**SCHEMATIC OF 90711 VFO.**  
 FIRST MADE FOR 90711

DESIGNED BY R.W.C. CHECKED BY E.G.J.  
 DRAWN BY H. COTTERLY JR APPROVED  
**JAMES MILLEN MFG. CO., INC.**  
 MALDEN, MASS., U.S.A. **M90711**

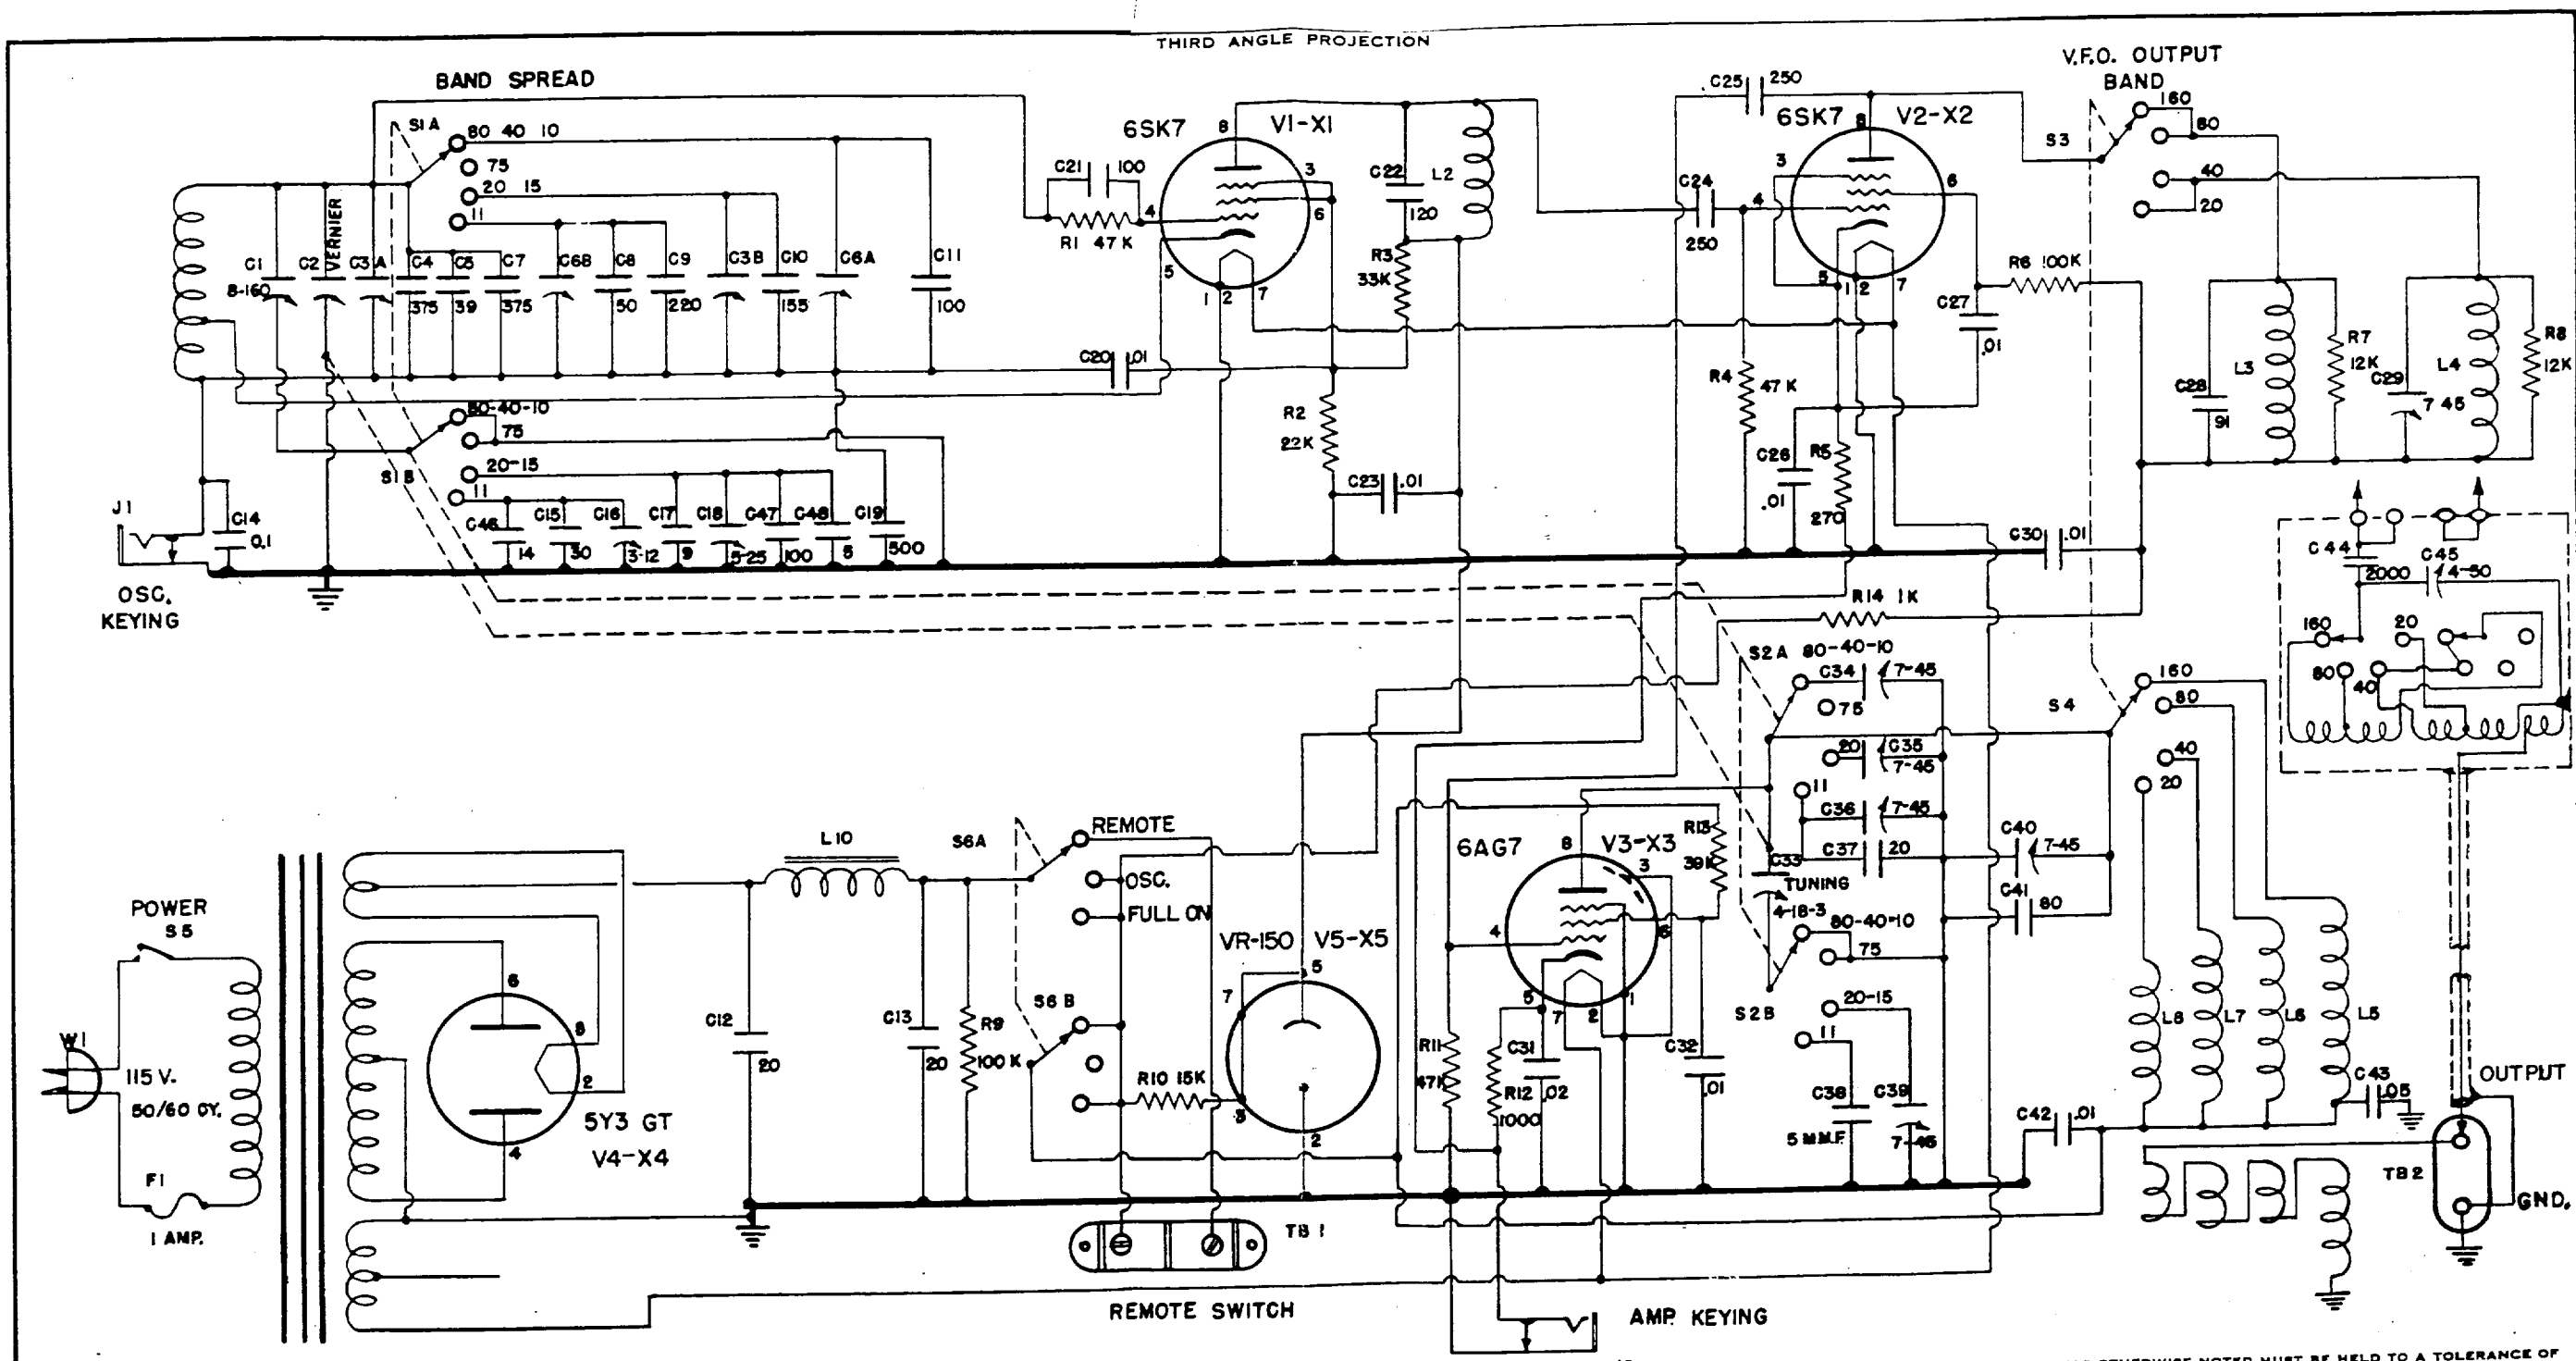
- 12-7-48 (3) V2 B Supply was connected directly to V3 B Supply
- 12-7-48 (2) C17 added) output changed C48 - 5 m mfd added
- 12-7-48 (1) C17 was 9 m mfd. added contacts on output S4
